Project Name: Naya Sales Center
333 W 41st St. MBCH

Project Number: B0701152

In response to your Electrical Review Comments, SEi Companies offers the following:

E-201

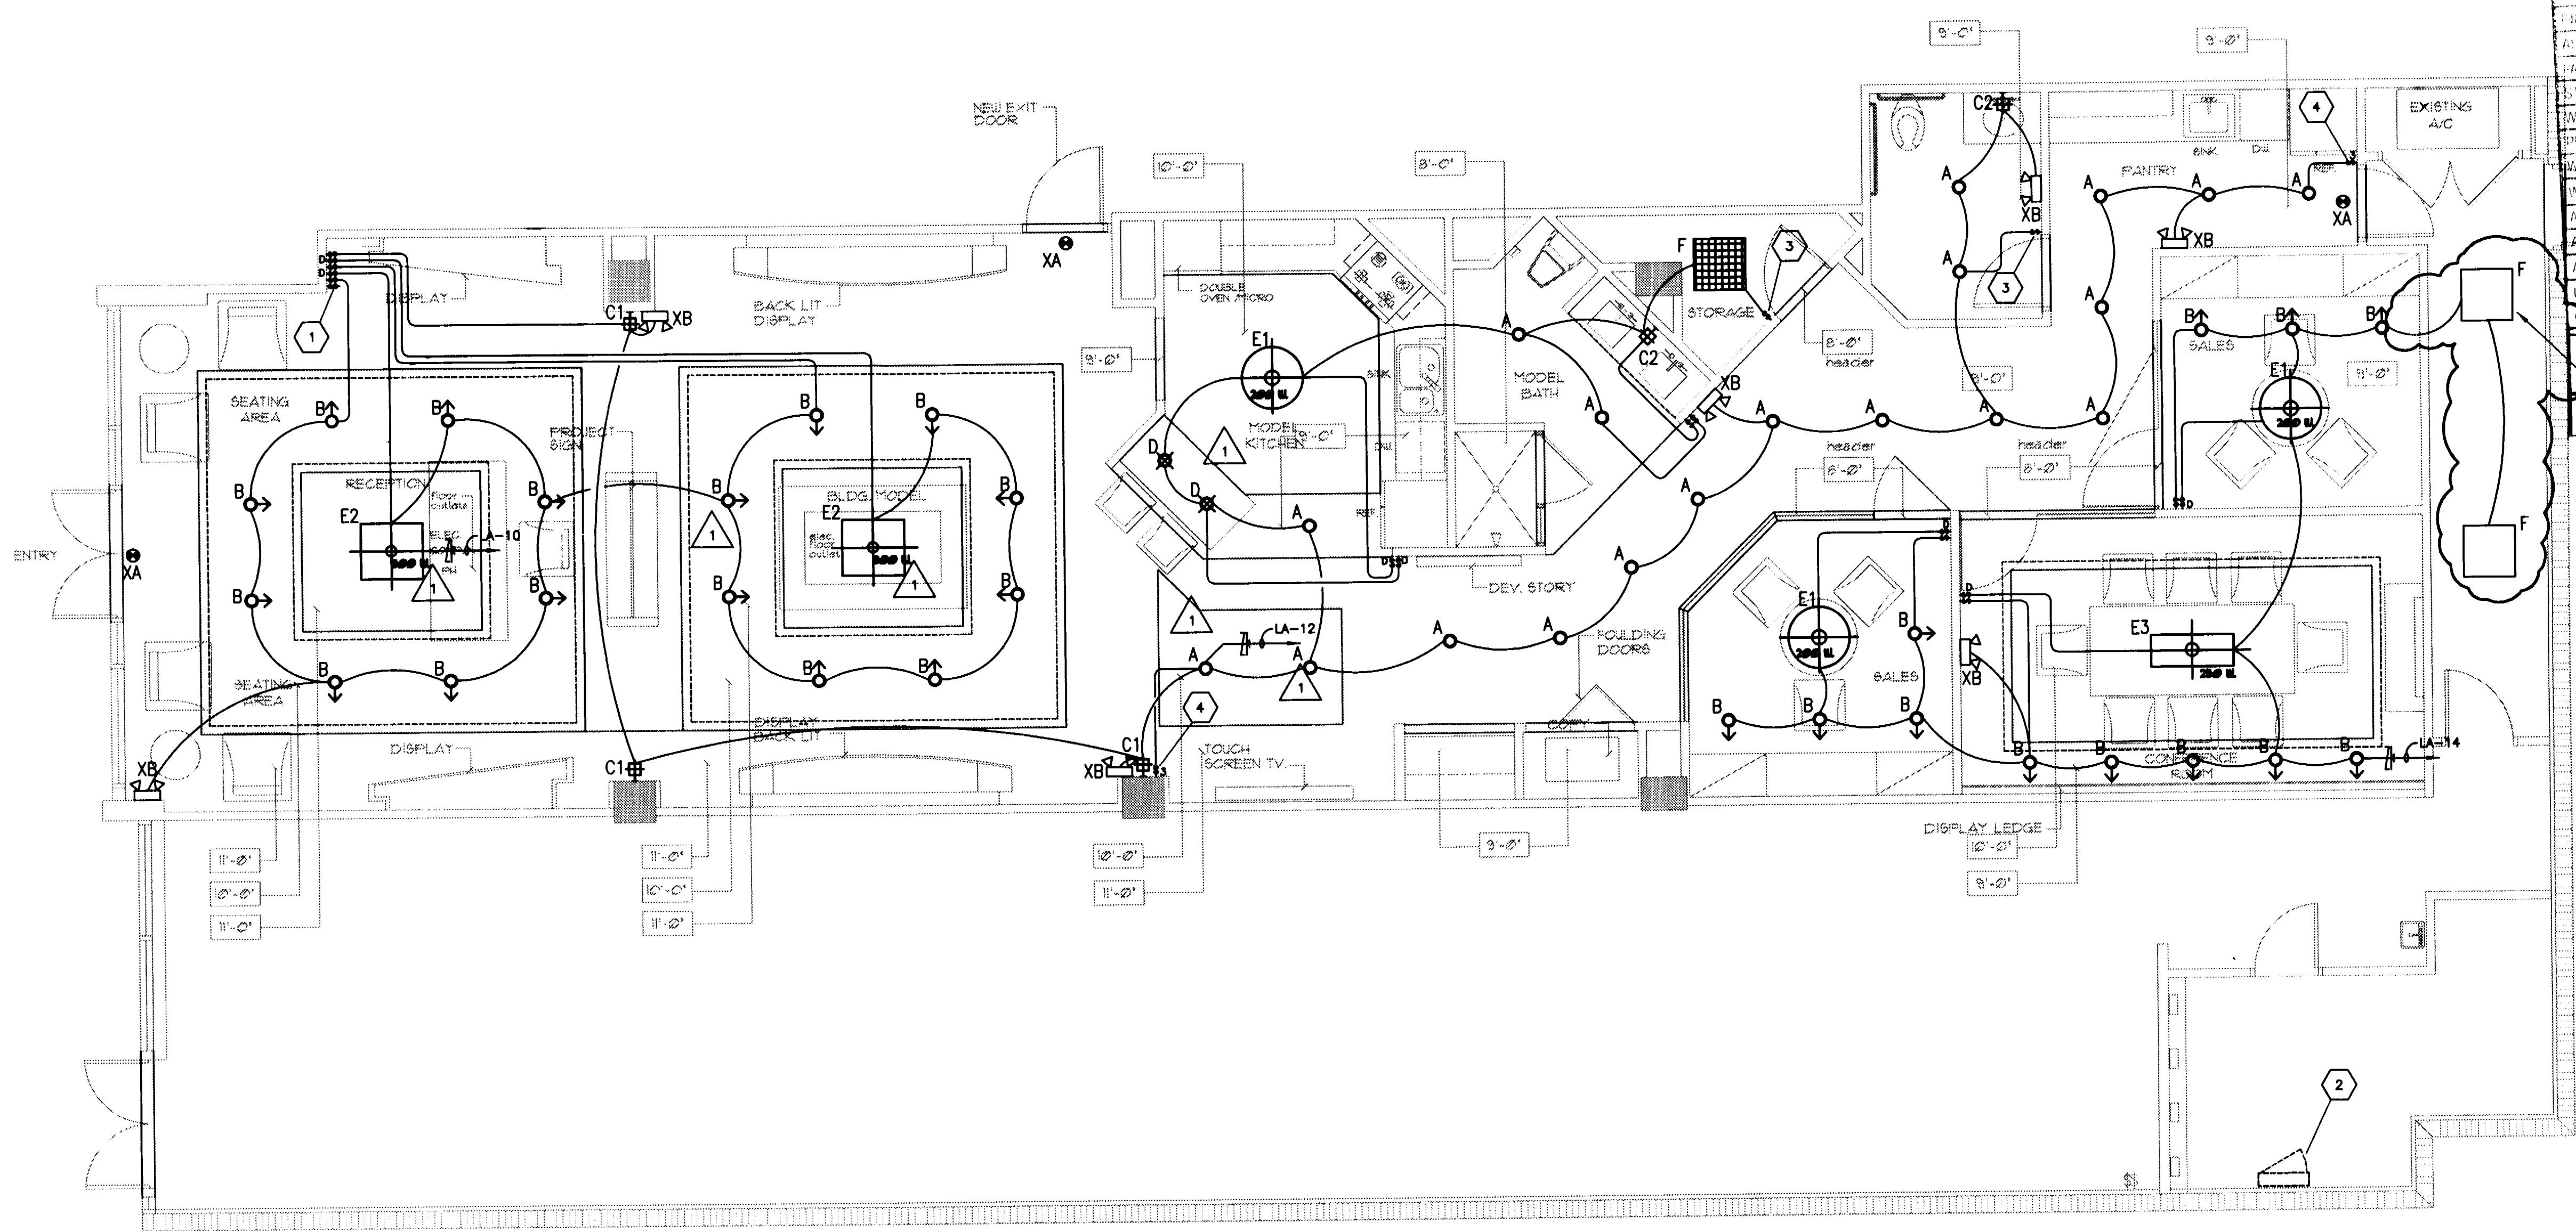
Comment #2: "Ok show emergency lighting for the exit corridor (in the rear)."

Comment #3: "Ok cannot have electrical panel in rated corridor."

Comment #4: "Check for the early warning thru out proposed space and show fire alarm devices need to provide the candela rating for the strobes."

Response: Emergency lighting has been added. Refer to Sheet E-201.

Response: Electrical panel is now located in a dedicated electrical room. Refer to Sheet E-201.

Response: Refer to Sheet E-201 general note #3. Candela ratings have been added to all fire alarm devices.

E-301

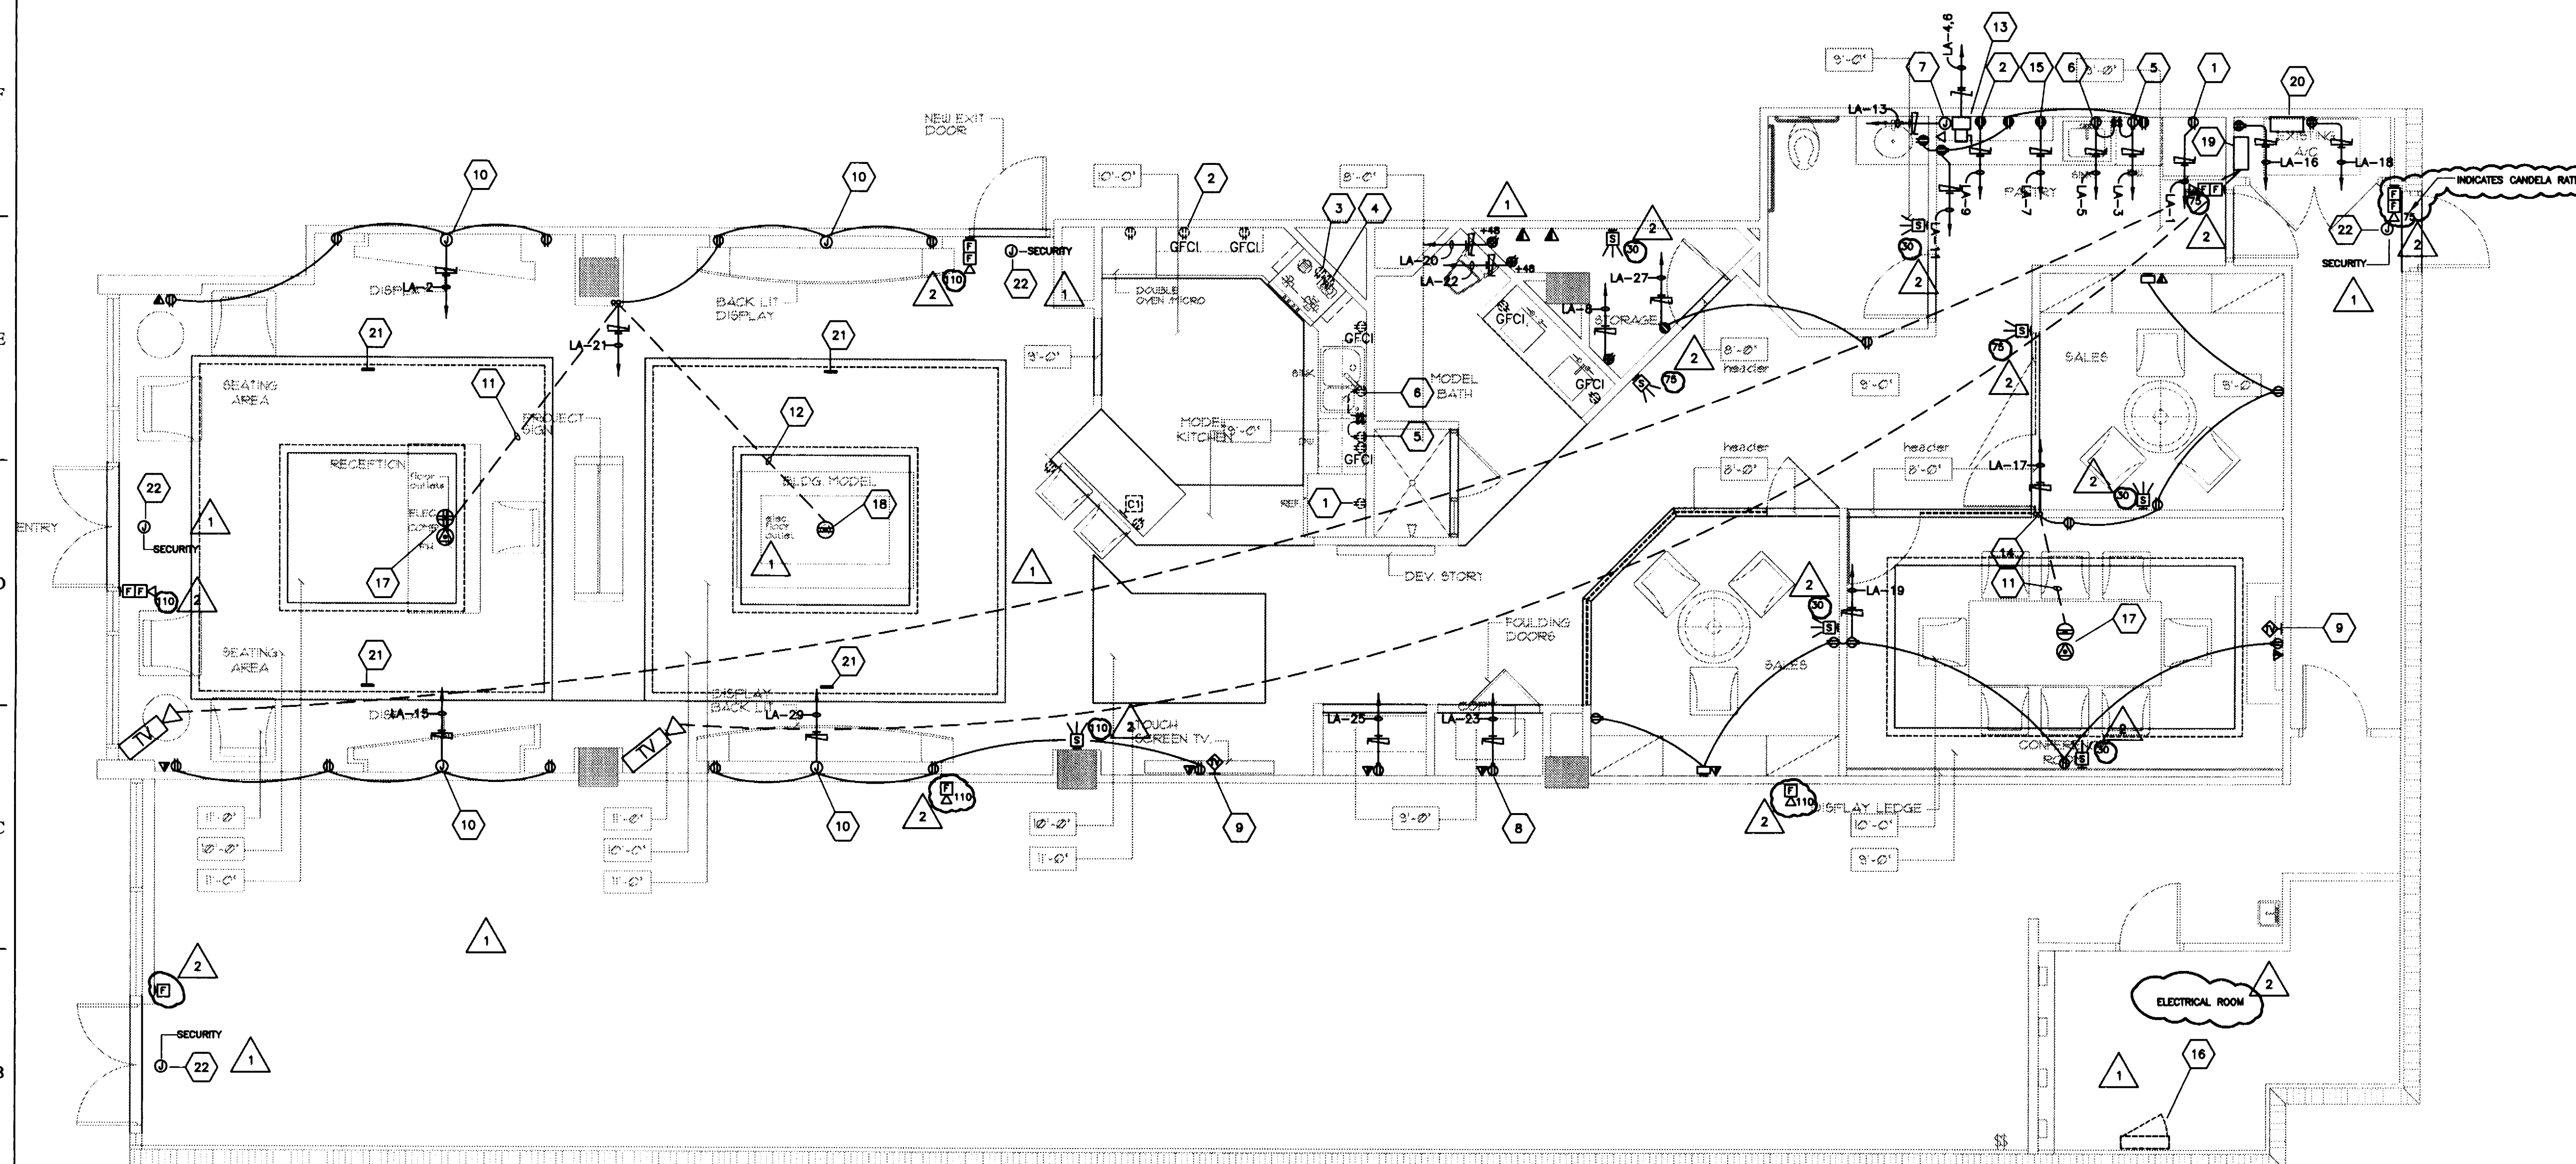
Comment #1 "Show fire alarm devices for the space and the building lease space."

Response: Fire alarm devices here been added. Refer to Sheet E-301.
